ABBREVIATED PLAT AGENDA

March 13, 2024

STAFF REVIEW AND RECOMMENDATIONS
PUBLIC HEARING
MARCH 13, 2024

ABBREVIATED PLAT: AURORA VIEW ESTATES 2024
LEGAL DESCRIPTION: SEC 30, T17N, R03E S.M., AK
PETITIONERS: CALVIN HALL
SURVEYOR/ENGINEER: KEYSTONE SURVEYING & MAPPING
HOLLER ENGINEERING
ACRES: 4.42 +/- PARCELS: 2
REVIEWED BY: CHRIS CURLIN CASE #: 2024-019

Agenda Copy

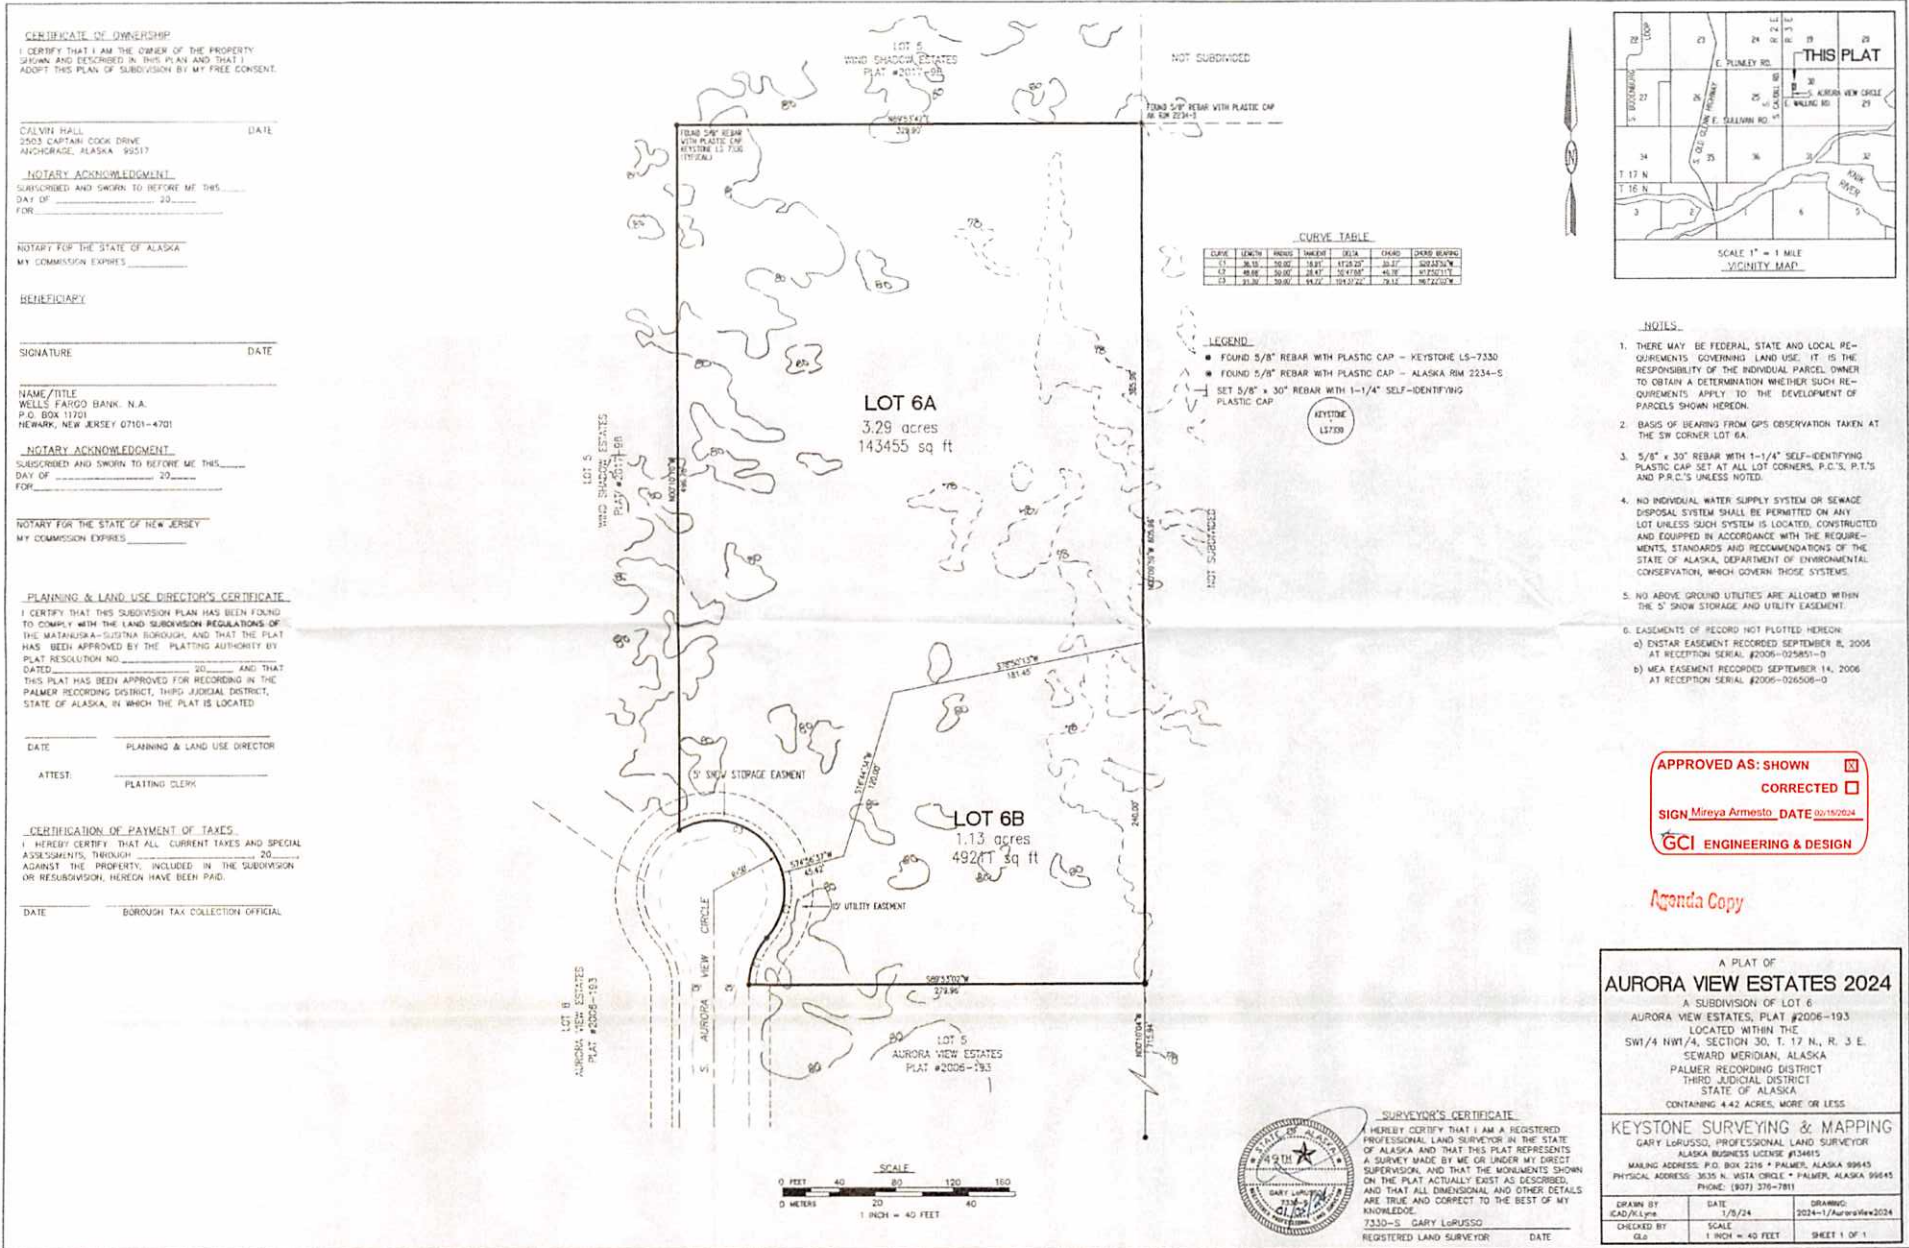
The 5' easement shown as a snow storage easement should be labeled as a snow storage & utility easement.

MTA has reviewed Aurora View Estates 2024 and would like to request the 5' Snow Storage Easement shown on the Agenda Plat be labeled '5' Snow Storage & Utility Easement' like it does on the plat 2006-193.
